Parrys Quarry Environmental Permit Application

Schedule 5 Questions and Responses

Response to Schedule 5 information provided 18/02/2014

DRAWING No. 30030/ESID/13A

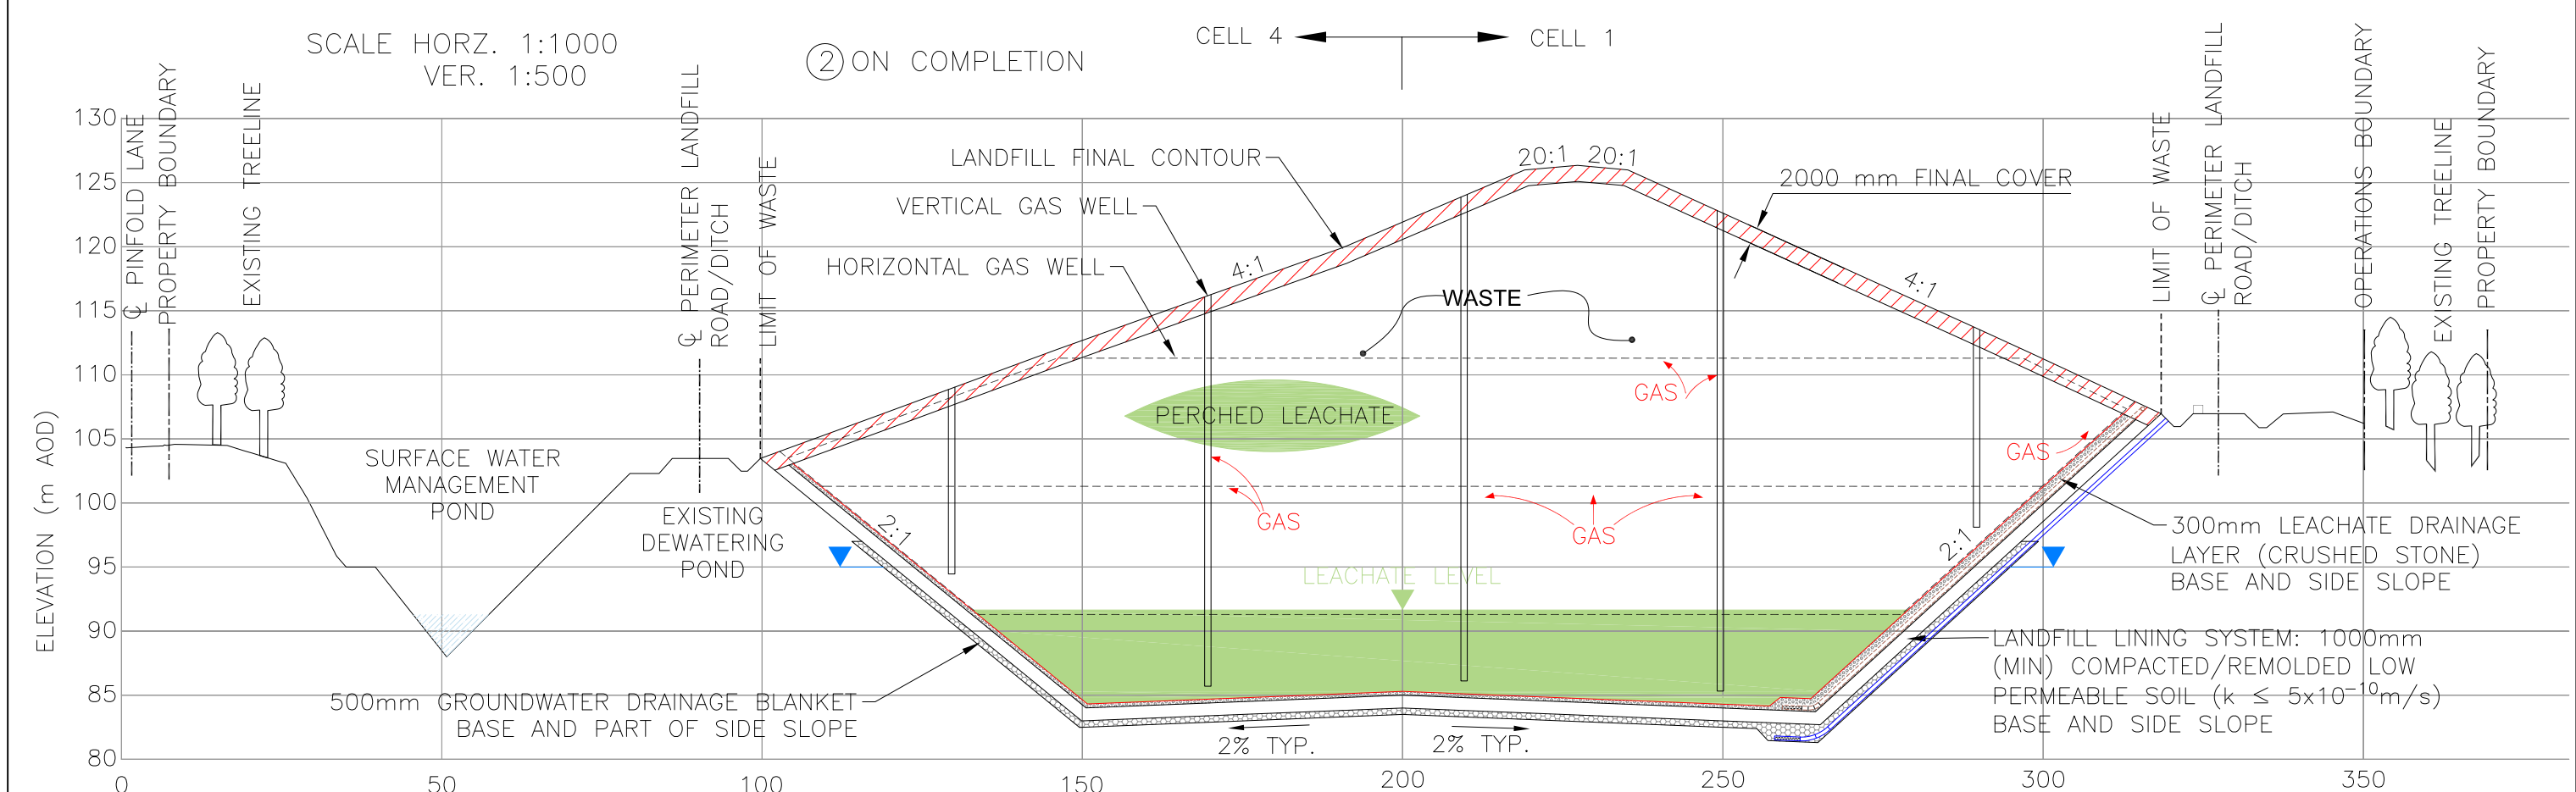
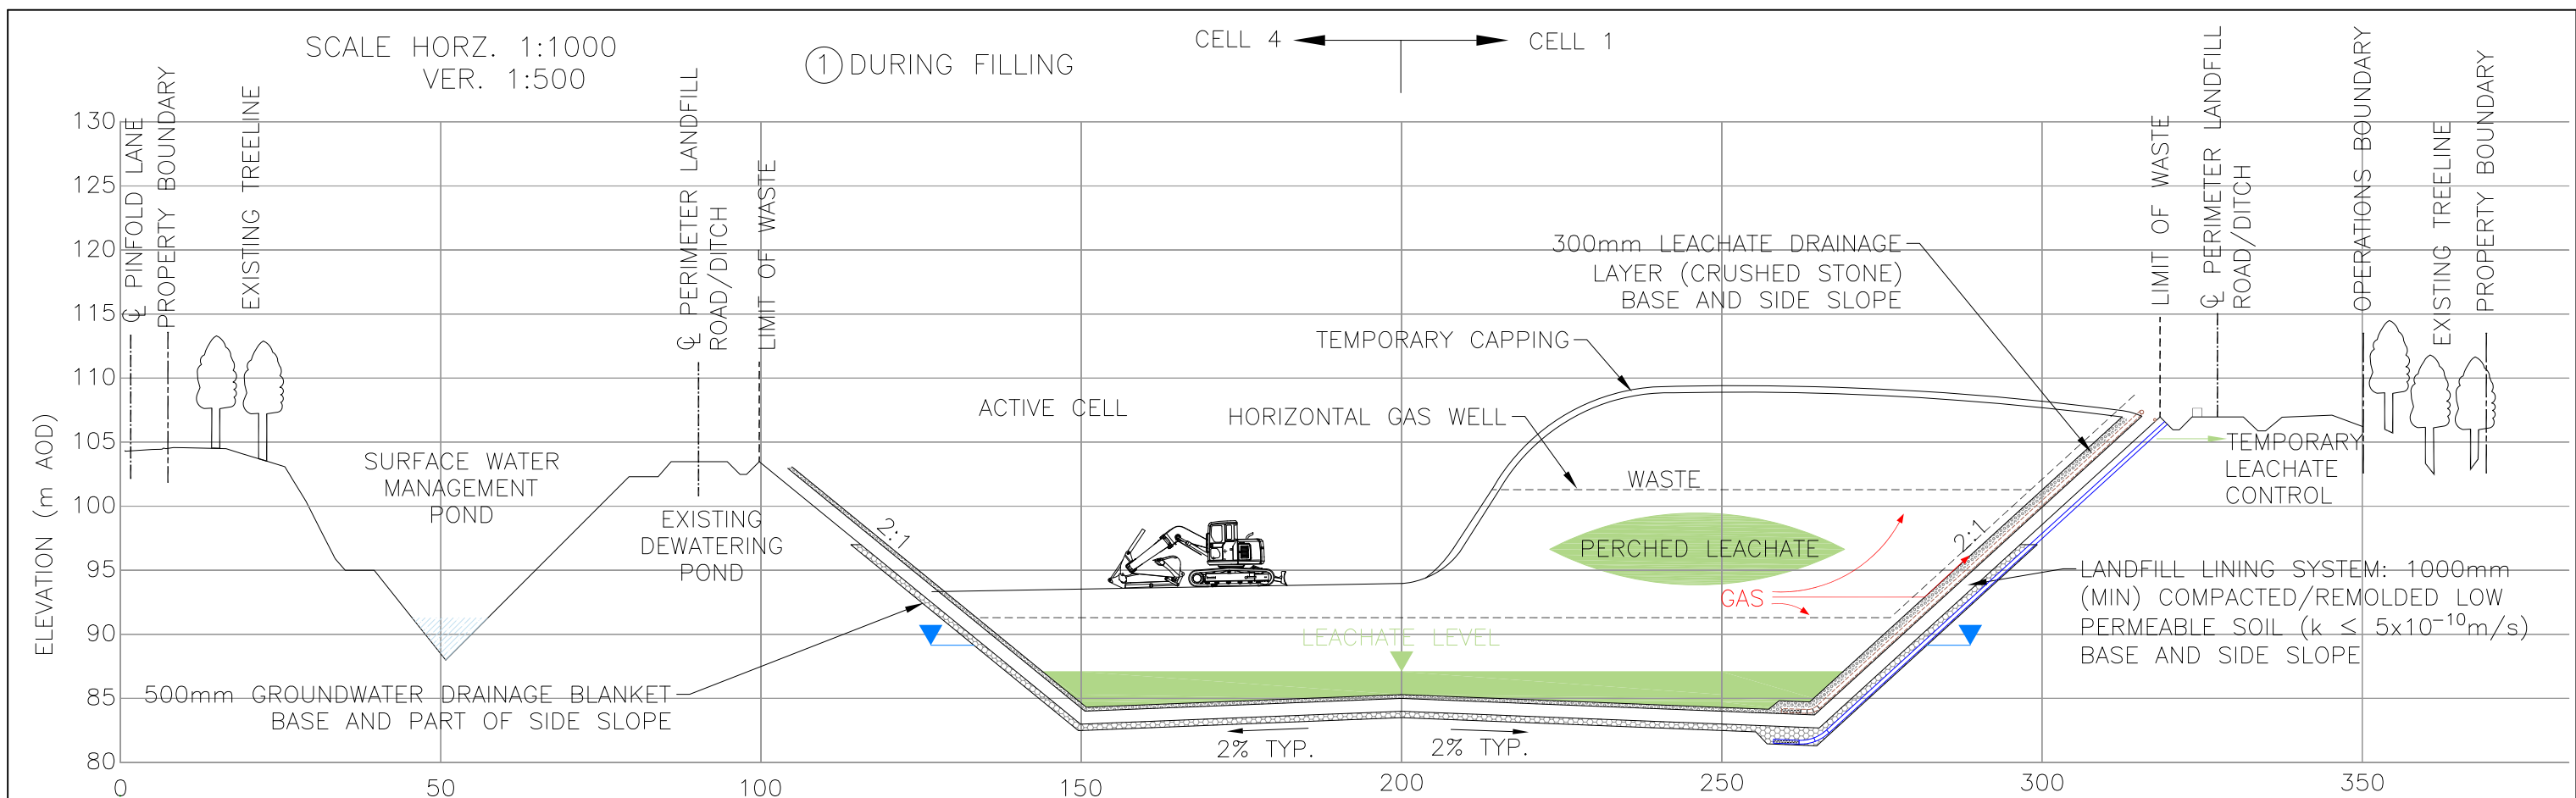
Revised drawing 30030/ESID/13A shows the location of proposed leachate monitoring points. We are satisfied that this provides good coverage of the central part of the landfill to address our previous comment about a lack of monitoring in this area.

We support the installation of additional boreholes and are satisfied that these can be undertaken as a pre-operational condition. We are however concerned that the three additional boreholes proposed do not provide sufficient coverage of the site. As the site will, in future, be reliant on hydraulic containment and being able to relate leachate heads within the landfill to adjacent groundwater levels, it is vital to have sufficient monitoring in place. Based on revised drawing ESID/13A which shows the proposed location of new boreholes there is a lack of groundwater monitoring along the

Please propose locations for additional boreholes (in addition to the three already planned) to address these gaps in coverage. A selection of these new boreholes should also be completed as multi-level installations (double or triple installation) to ensure representative measurement of groundwater levels and quality. Most of the existing boreholes being retained have long response zones which makes them unsuitable for water quality monitoring. Having a long response zone through different horizons allow any poorer quality water to be diluted in the water column. The new boreholes which are installed should be completed as multi-level installations with shorter response zones to ensure water quality is representative of the adjacent strata. This will be required to determine whether the landfill meets the compliance limits set for groundwater.

It is proposed to drill 7 no. new boreholes (PQGW1A, PQGW2, PQGW3, PQGW5, PQGW08, PQGW9 and PQGW10) around the periphery of the site. These boreholes will target the more permeable horizons (sandstone bands) below the water table. The proposed locations are shown on revised Drawing ESID/13A rev 4 attached.
